CITY OF
SIERRA MADRE

PLANNING COMMISSION
REGULAR MEETING AGENDA

a. Design Review Permit (DRP 25-02) related to the implementation of The Meadows at Bailey Canyon Specific Plan for the construction of forty-two single-family dwellings and a three-acre park.

SUBJECT: **Design Review Permit (DRP 25-02), Implementing The Meadows at Bailey Canyon Specific Plan, for the Construction of Forty-Two (42) Detached Single-Family Dwellings**

Figure 1

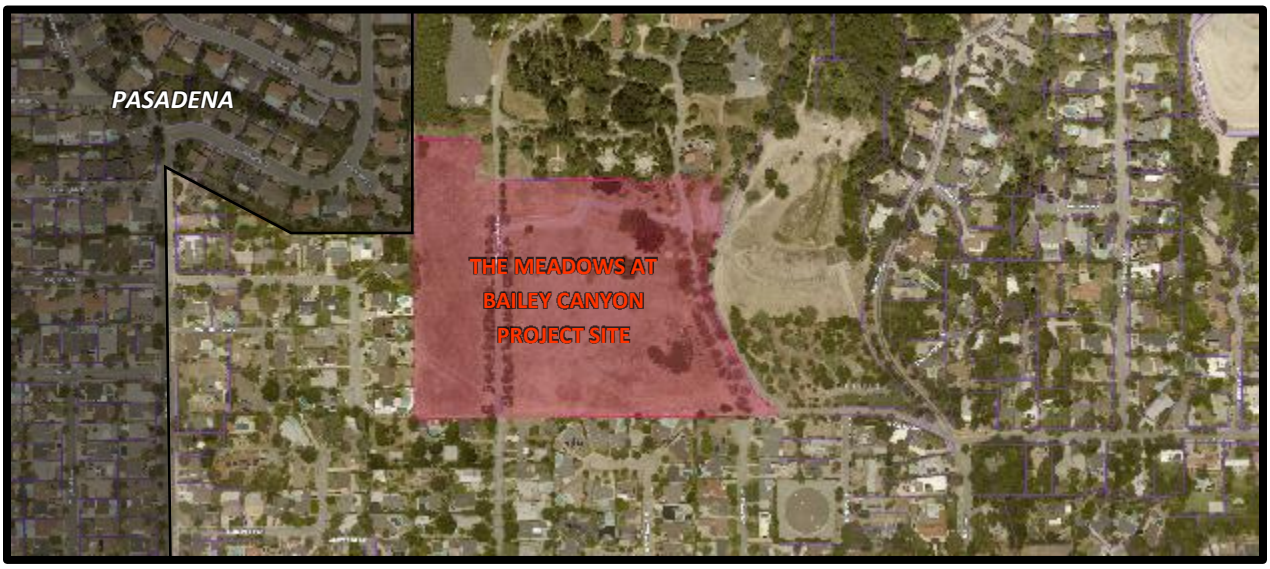
The typical standard of floor plan configuration for these homes is orientation with the garage on the right-hand side of the building façade. Plans that have been mirrored are indicated with an "R" appended to the plan identifier (example: Lot 19 is Plan 2AR because its garage is oriented on the left-hand side of the building façade). Single-story dwellings are located on residential lots predetermined by the Specific Plan (Lots 10, 11, 14, 21, 22, 31, 32, 34, 35, 36, 37, and 42) as illustrated in Figure 1.
